Remarks/Arguments:

Applicant respectfully requests reconsideration of the present application in view of the above amendments and following remarks. The specification and claims 1, 7, and 12 have been amended, claims 10 and 13-18 have been canceled, and claims 19-28 have been added. Claims 1-9, 12, and 19-28 are pending in the present application.

Fig. 1

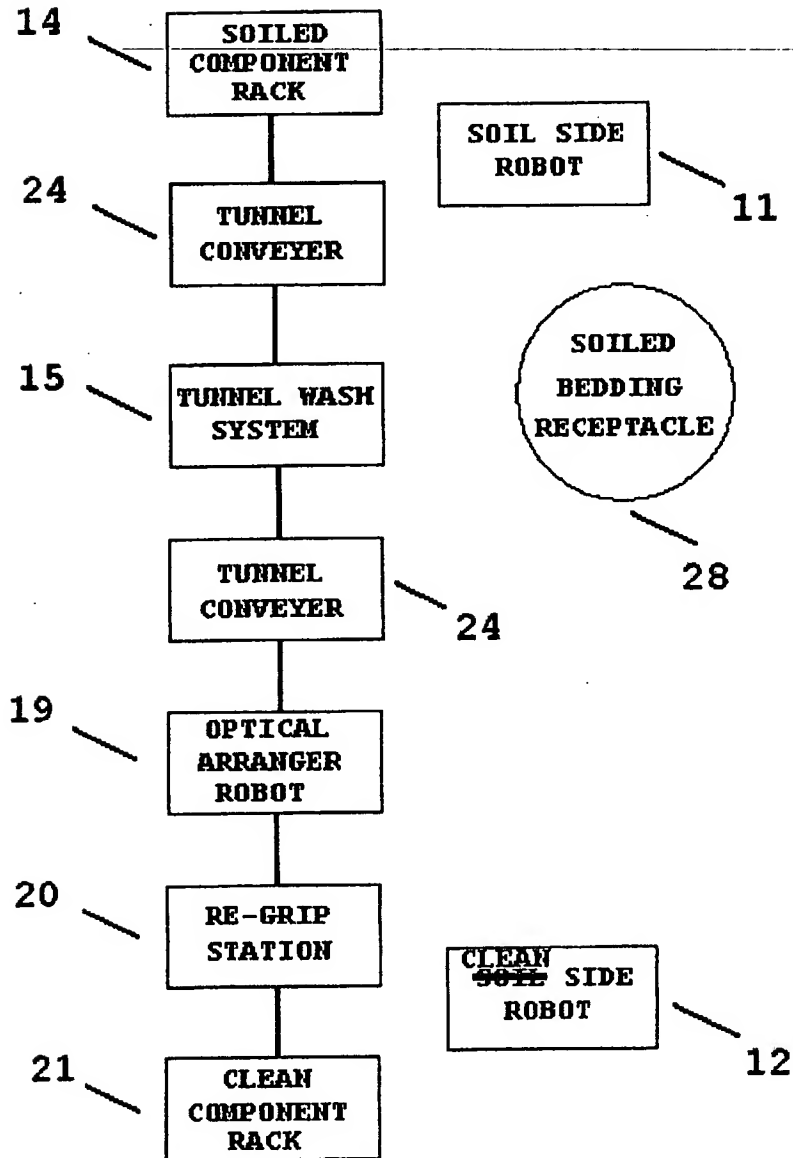
The objection to the drawings arises because the reference character "45" has been used to designate both the lower surface and the vertical coupler turret. The use of the reference character "45" on page 10, line 16 of the application is a typographical error. The reference character "45" in that line should have been "55," and the specification has been amended to correct the error. The reference character "45" only appears once in the drawings.

FIG. 1 has been amended to correct the label in box 12. The application, on page 6, lines 6 and 7, refers to box 12 as representing the clean side robot.

The attached drawing sheet includes a change to FIG. 1. This sheet replaces original drawing sheet of FIG. 1. In FIG. 1 label in box 12 has been changed from "SOIL SIDE ROBOT" to "CLEAN SIDE ROBOT."
